File No.: ZDO-270: TSP Minor Amendments

Land Use Hearing Item Staff Report to the Board of County Commissioners

File Number: ZDO-270, Updates to Figures, Maps and Tables for Comprehensive Plan Chapter 5, Transportation System Plan

RE: ZDO-270: Updates to Figures, Maps and Tables for Comprehensive Plan Chapter 5
Transportation System Plan

**Figure
7-1A**

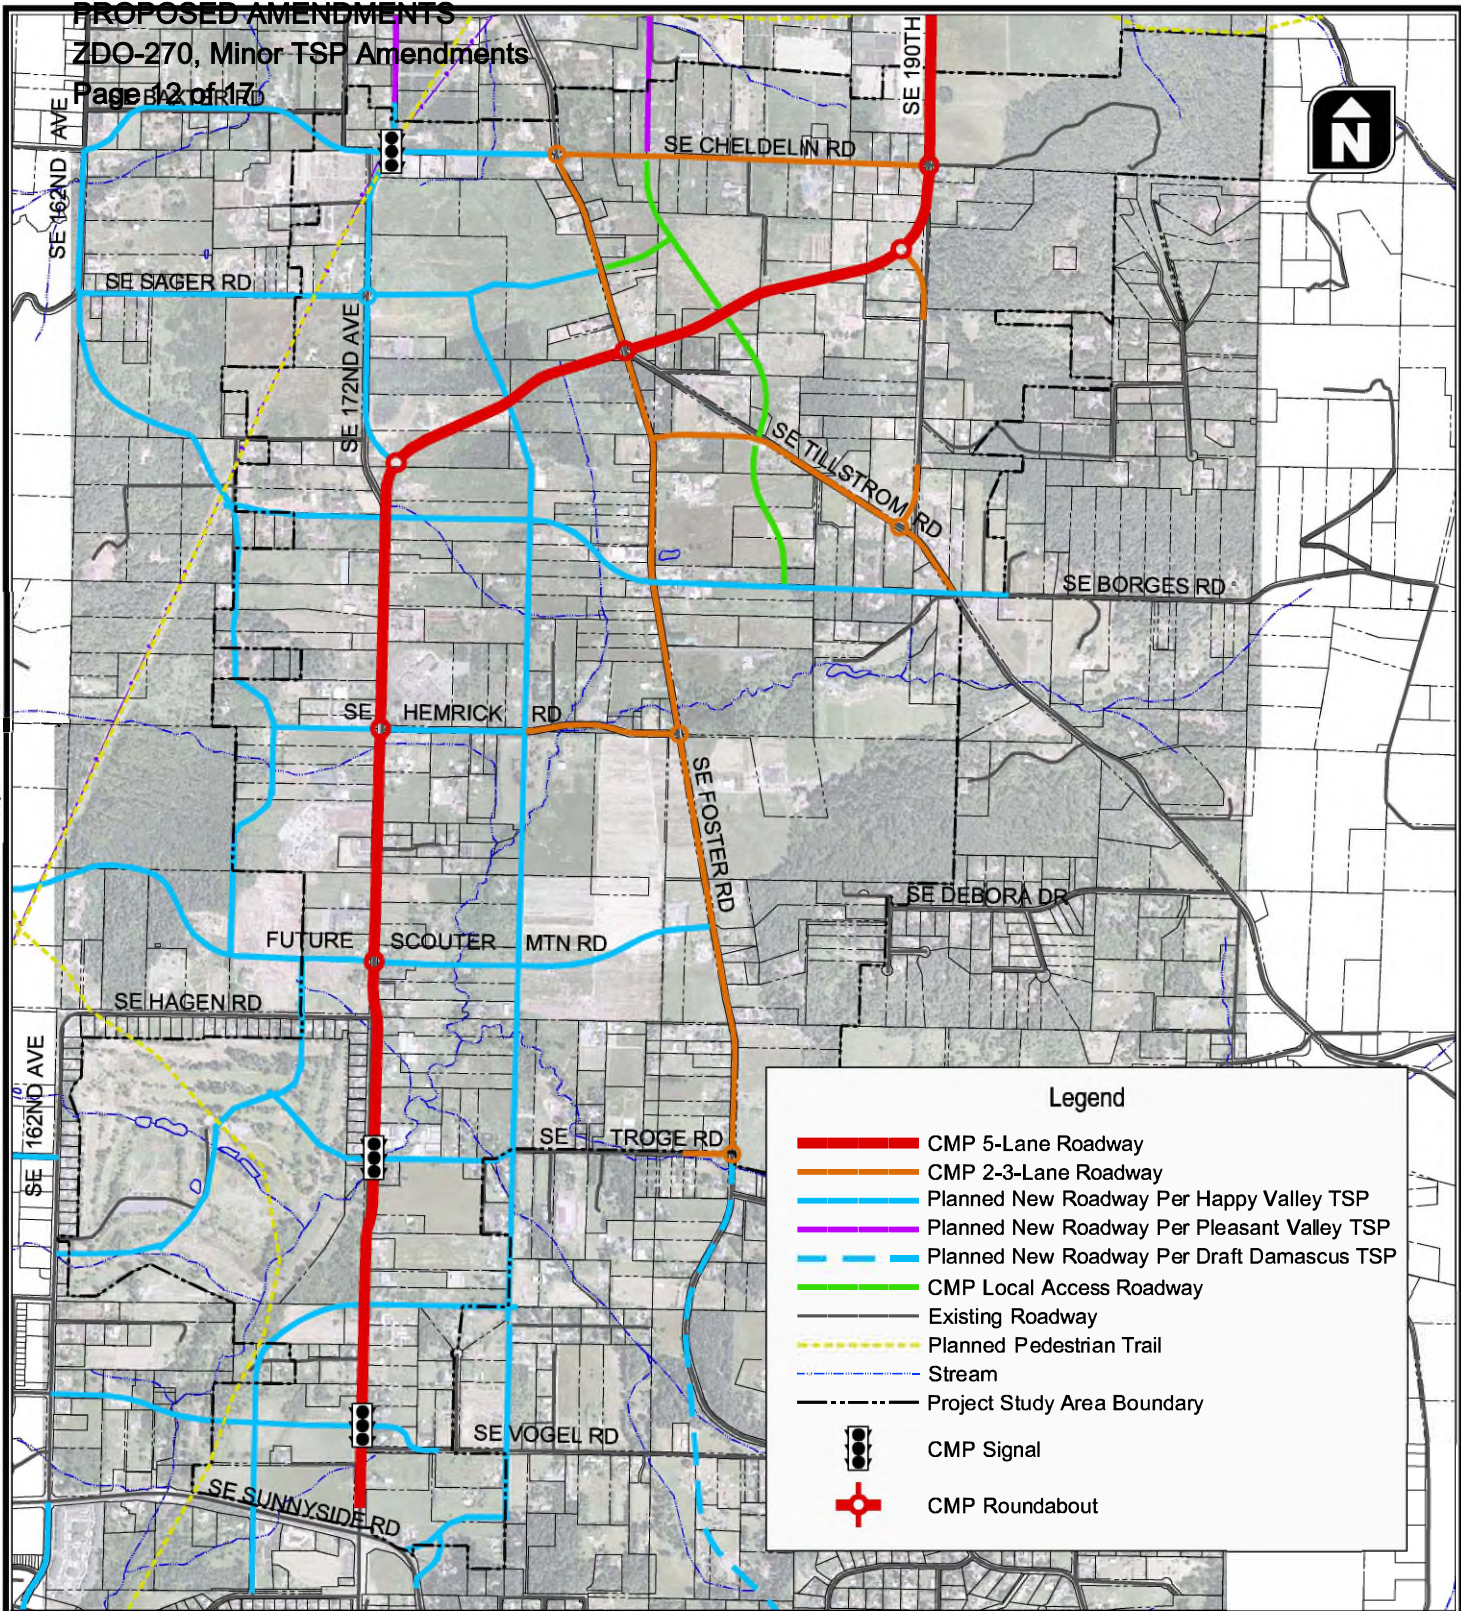
- e. **Revisions to Figures 7-1A, 7-1B, 7-2A through 7-2D, and 7-3A** – In their most recent Transportation System Plan update, Happy Valley revised several roadway network designations and cross sections, which had been included in the SE 172nd/190th Drive Corridor Management Plan. Since those were amended in the city TSP, and the corridor has been annexed into the City of Happy Valley it was necessary to amend them in the Corridor Management Plan to maintain consistency. Although Clackamas County has no authority over roadway network designations and cross sections in Happy Valley, it is necessary for the county to adopt the updated Corridor Management Plan that includes those changes.

Proposed Update to Transportation System Plan

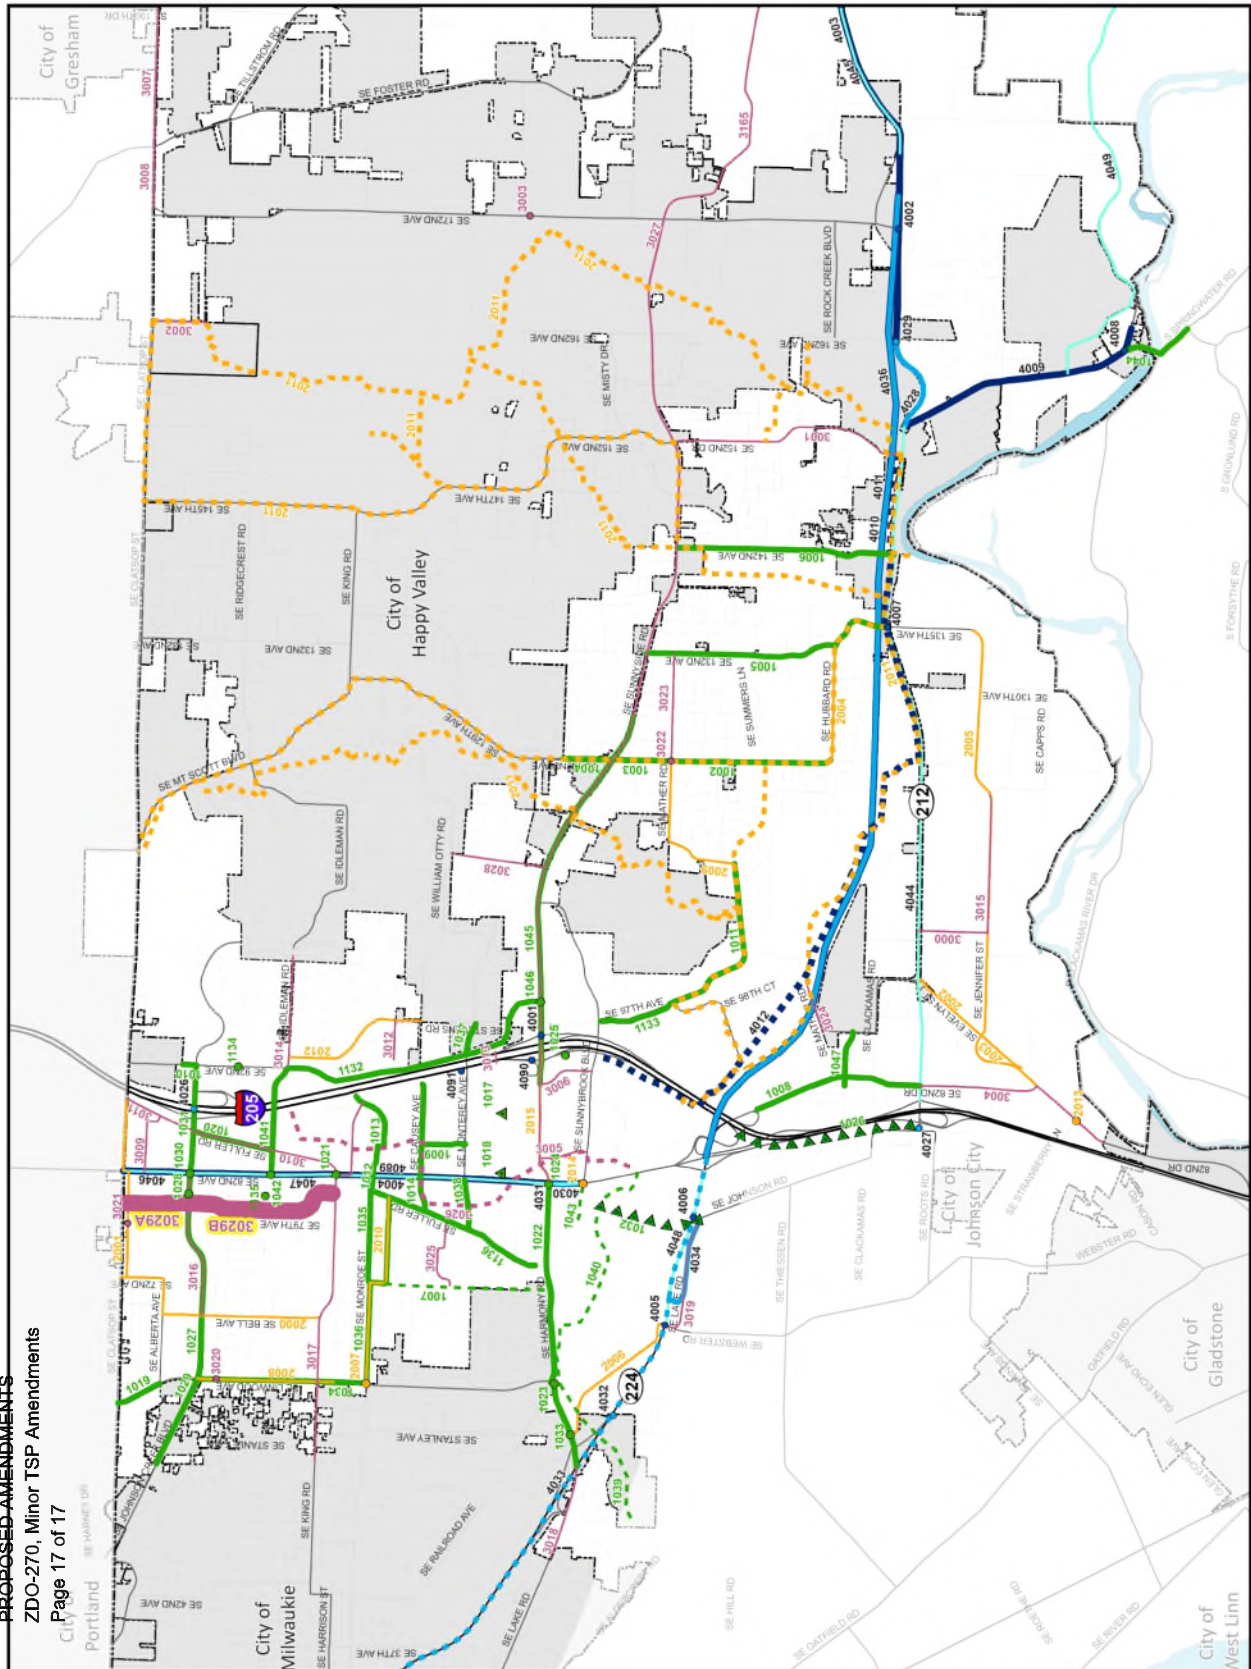
This proposed modification would replace #3029 with #3029a and #3029b. Both replacement project would have the same project name (West 82nd Ave Parallel Road) and the same description (see attached table). New project #3029a would extend 79th from Luther Road to Johnson Creek Boulevard, and new project #3029b would extend 79th from Johnson Creek Boulevard to King Road (see attached map).

If this proposed amendment is approved it will be incorporated into Comprehensive Plan, Chapter 5 – Transportation System Plan by modifying Table 5-3c Long Term Capital Projects and Map 5-11a to remove Project ID #3029 and replace it with two projects with the same description: #3029a extending from Luther Road to Johnson Creek Boulevard, and #3029b extending from Johnson Creek Boulevard to King Road.
